**CITY OF MILL CREEK
DESIGN REVIEW BOARD
APPLICATION PL2019-0010**

NAME OF PROJECT: Creekside Phase II

PROPOSAL: Review of building elevations and landscaping.

A New Office Building for:
Creekside Building
18614 9th Ave SE
Mill Creek, Washington
Contents:
BUILDING #3 EXTERIOR ELEVATIONS

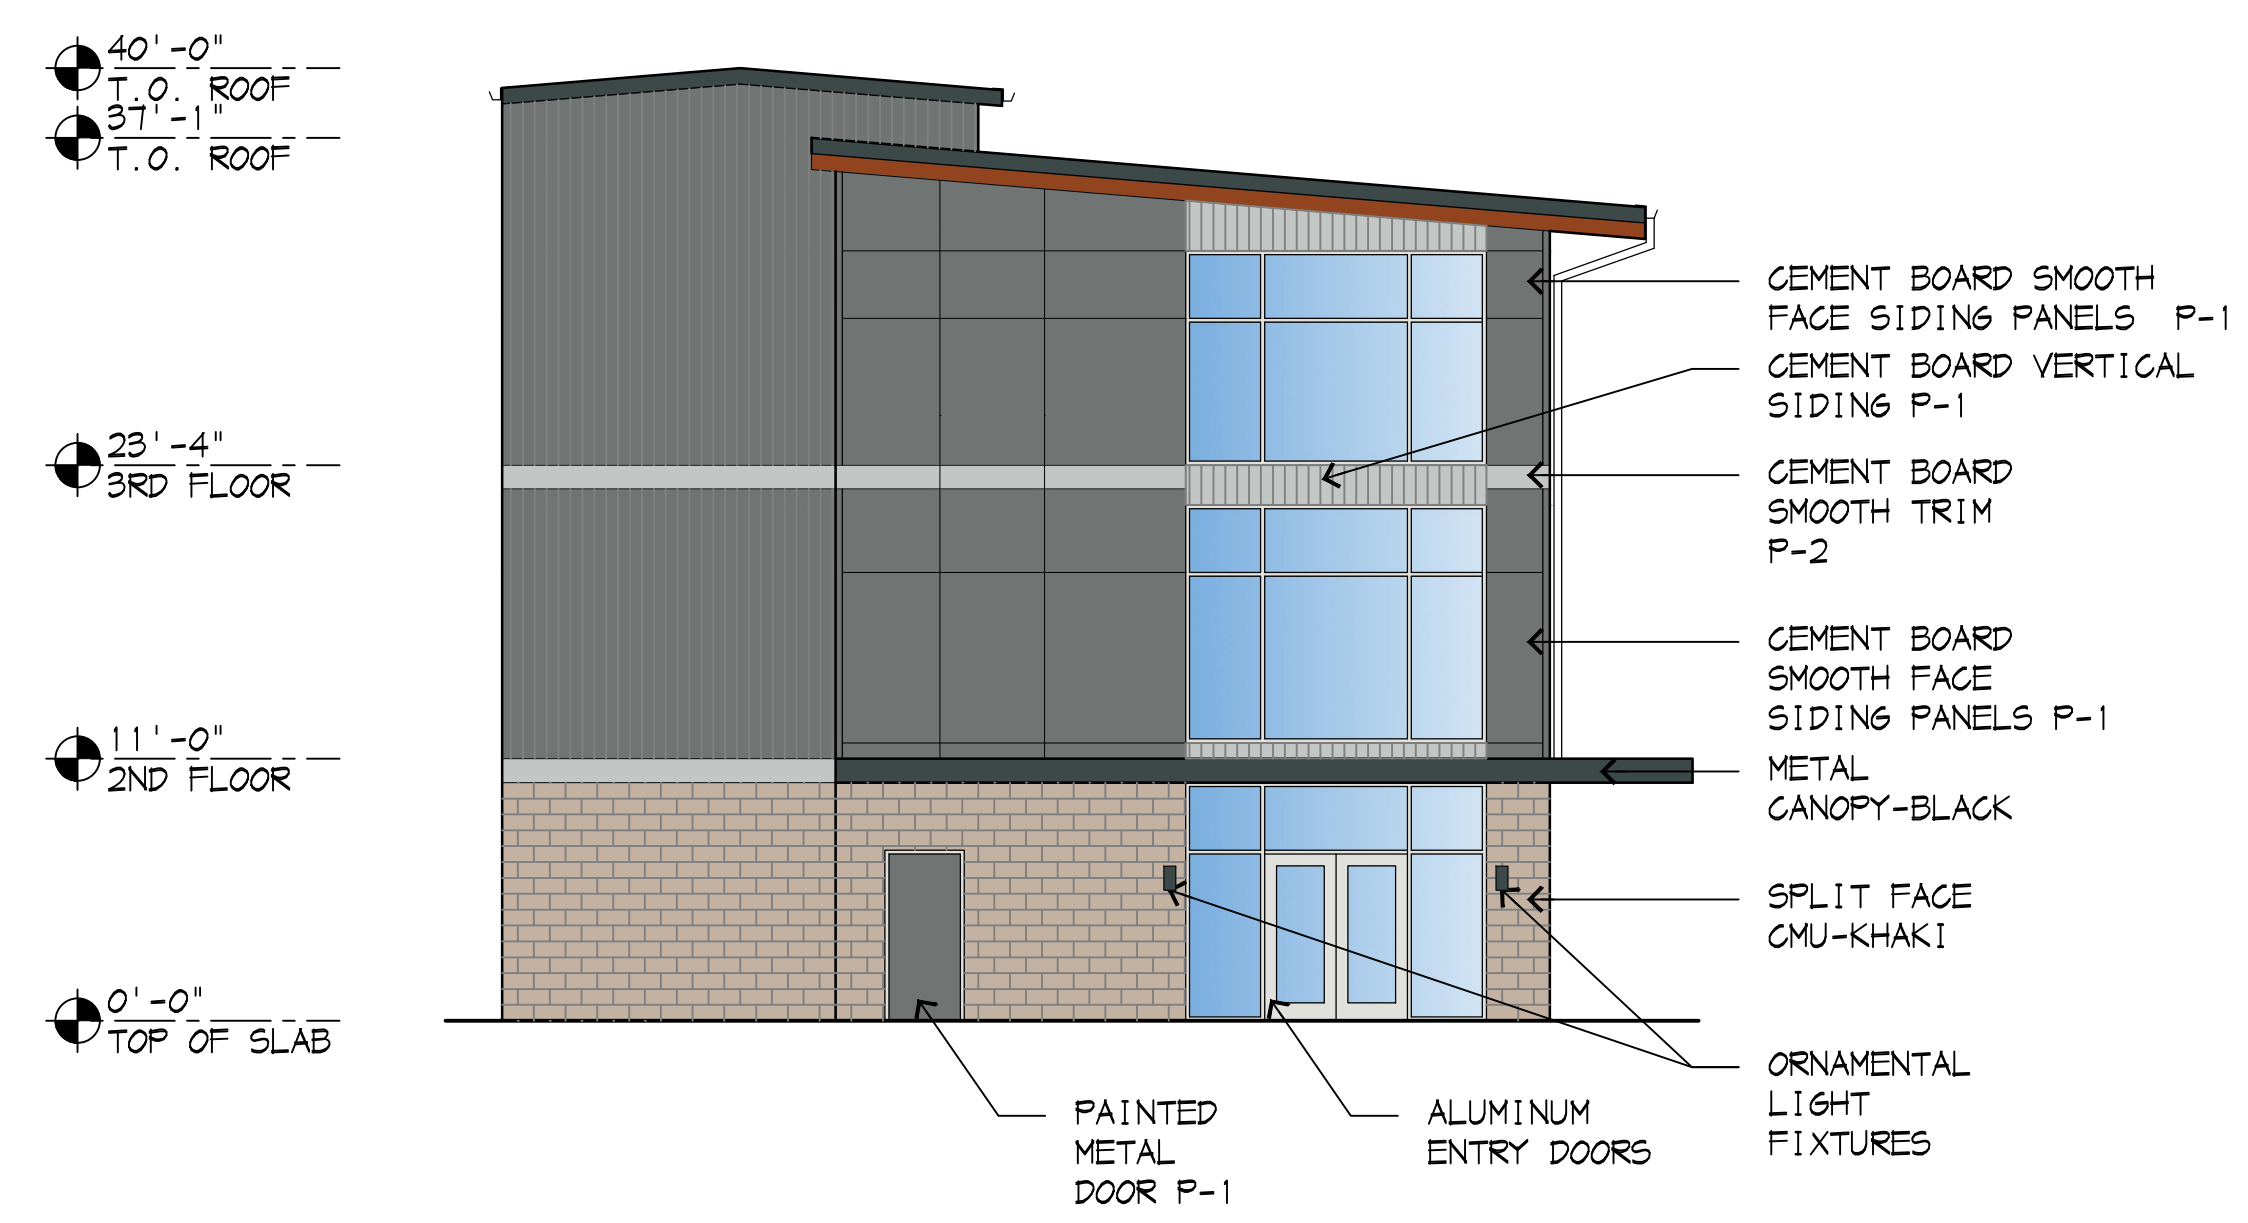
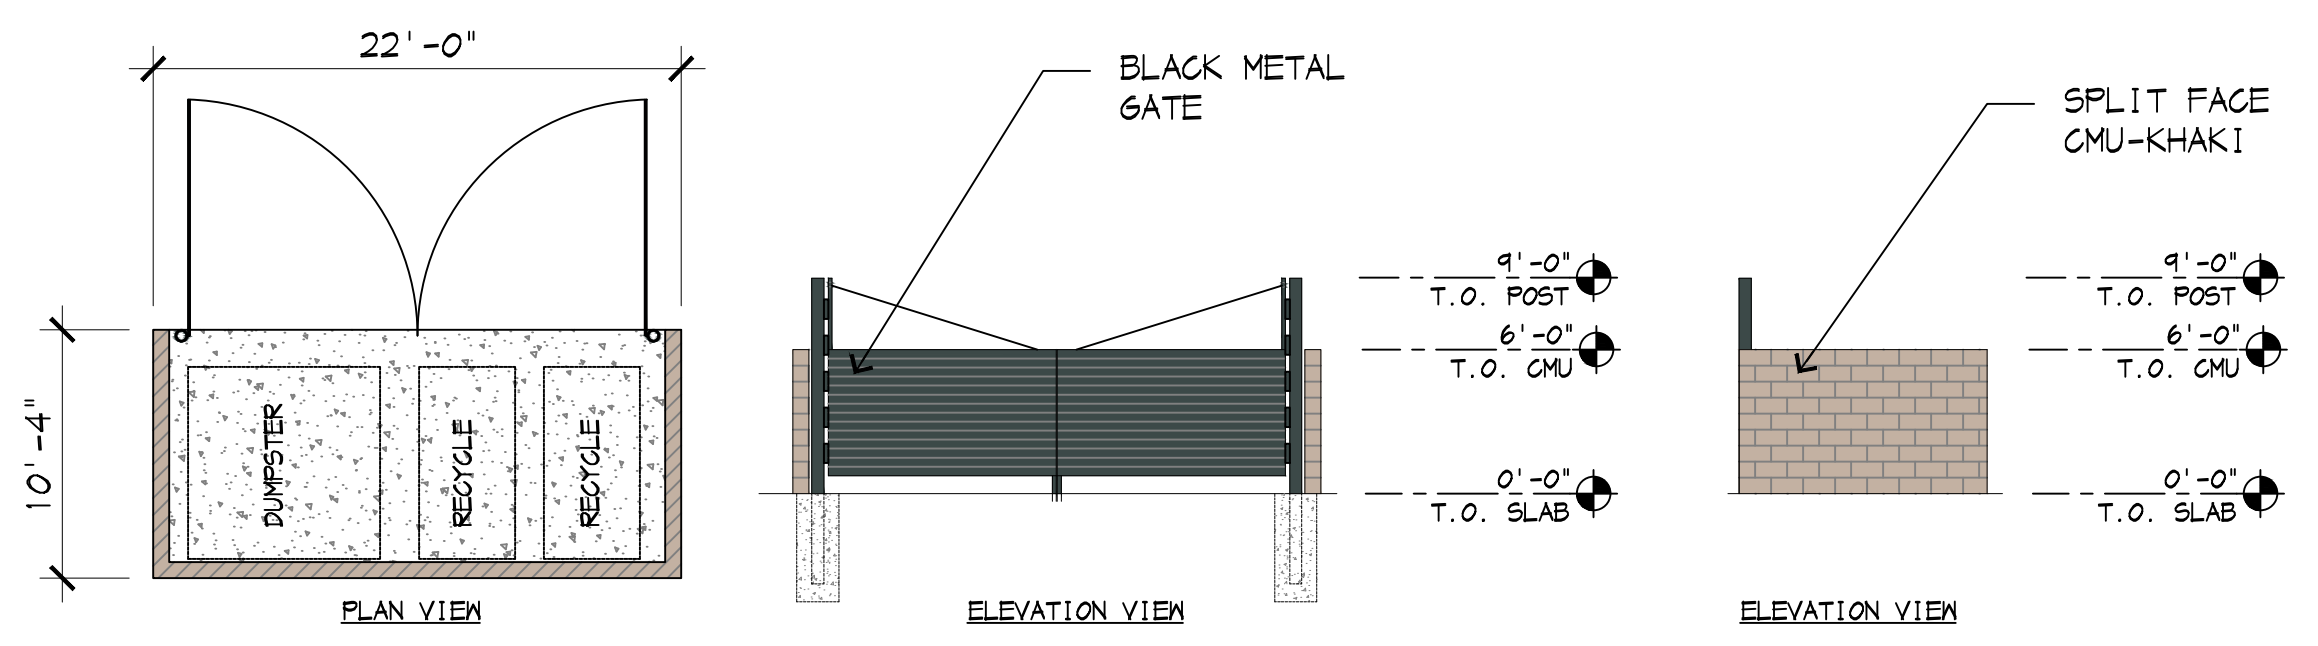
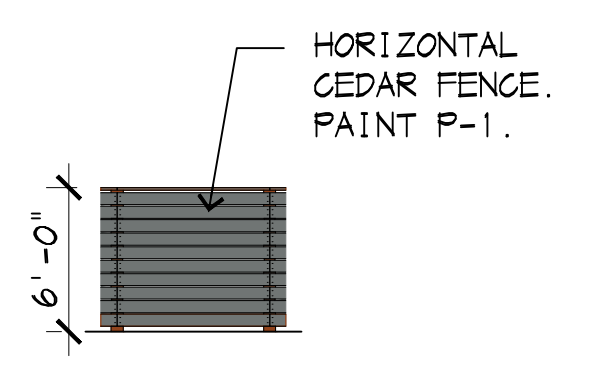
The proposed building exterior materials include a combination of cement board in smooth, horizontal lap siding and vertical siding all in a medium gray color identified as Sherwin Williams Software 7074 and smooth trim and vertical siding in light gray identified as Sherwin Williams Gray Screen 7071. The ground floor is anchored with split face CMU in Khaki. The building materials have been selected to coordinate with the existing office building (Creskide Phase I) located across the parking lot at 16504 9th Avenue Southeast (**See attached photos**). Building modulation has been incorporated to ensure that no exterior wall will be longer than 50 feet without an offset or setback. To avoid blank walls, the architect has chosen to use a masonry base, belt course of a different color, variation in the texture of the cement board siding, windows – in particular the large windows highlighting the entry, and a projecting black metal canopy over the entry doors.

The trash enclosure is located in the southwest corner and is proposed to be constructed of split face CMU in Khaki and have a solid, black metal gate. The mechanical equipment, located on the western elevation, will be ground mounted and screened by a horizontal cedar fence painted in the dark gray to coordinate with the building. (See *Attached Project Narrative, Color Elevations -- Sheet A-3.1, and Floor Plans -- Sheet A2.1*)

Staff believes that the building elevations comply with the intent of the design guidelines contained in the Code and is recommending approval as proposed.

LANDSCAPE
PLAN

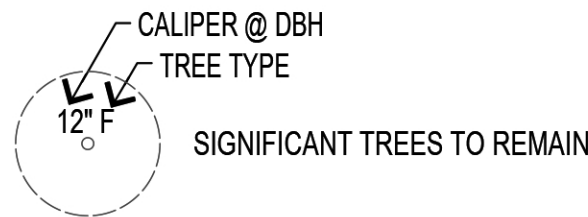
corner or the parking lot, and around the perimeter of the parking lot adjacent to the critical areas. The 9th Avenue Southeast frontage is landscaped with Pacific Sunset Maple, Excelsa Cedar, and Vine Maple, shrubs and ornamental grasses and groundcover. In addition, there is an existing small, landscape bed in the sidewalk on 9th Avenue Southeast that is currently bare dirt and weeds. Staff is recommending that this bed be planted with at least groundcover to help prevent future maintenance/weed issues. See *Attached Landscape Plan, Sheet L-1*.

The landscape islands and the landscape bed between the two interior rows of parking is proposed to be planted with Pacific Sunset Maple, shrubs and ornamental grasses. Parking lot lighting will also be located in the landscape islands. Staff has a concern that the Pacific Sunset Maple at a mature height of approximately 30 feet will conflict with the lighting and is recommending the selection of another tree species for the landscape islands.

The landscape bed in the southwest corner is proposed to be planted with an Excelsa cedar, two Vine Maple, shrubs and ground cover (Vinca Minor). The spacing on the Vinca Minor is proposed at 24 inches on center. It is not likely that the requirement for 90 percent coverage in three years can be attained with this spacing; thus, staff is recommending a Condition of Approval that the spacing be 18 inches on center.

The perimeter areas between the parking lot and the critical areas are proposed to be planted with a native shrub mix containing Salal, Oregon Grape, and Snowberry. The spacing on the shrub mix is proposed at 36 inches on center. It is not likely that the requirement for 90 percent coverage in three years can be attained with this spacing; thus, staff is recommending a Condition of Approval that the spacing be 24 inches on center.

- Root barrier is required with all trees within five feet of a paved surface, not just in the parking lot island planters, so it would also be required along the 9th Avenue Southeast frontage.

- The Mill Creek Planting Standards should be included on the plans.
- The original Binding Site Plan approval included a Condition of Approval that, “A 42-inch solid fence or wall be installed along the western edge of the parking lot to minimize lighting impacts from vehicles on wildlife habitat within the adjacent wetlands.” The fence or wall should be shown on the landscape plan.

- The Code states that, “Where parking lot design results in head-in parking adjacent to landscape areas, the landscape areas shall be protected by wheel stops or another method adequate to prevent damage by overhanging vehicles.” The plan should show wheel stops in the spaces adjacent to the perimeter landscape beds as well as the interior landscape bed.

- Provide landscaping (either shrubs or groundcover or a combination) in the landscape bed in the sidewalk on 9th Avenue Southeast.
- Place a couple of planter pots by the front entry doors.

2. Modify the landscape plan as follows:
 - Adjust the spacing on the Native Shrub Mix to 24 inches on center;
 - Adjust the spacing on the Vinca Minor to 18 inches on center;

- Show root barrier adjacent to the parking lot trees and the trees along the sidewalk on 9th Avenue Southeast;
 - Show wheel stops on all parking spaces;

- Show the fence/wall along the western edge of the parking lot and provide a detail of materials and colors;
 - Propose an alternate tree species for the two landscape islands by the interior parking spaces to avoid a conflict with the parking lot lighting; and

- Landscape the small bed in the sidewalk along 9th Avenue SE with either shrubs or groundcover or a combination.
 - Add planter pots by the front entry.
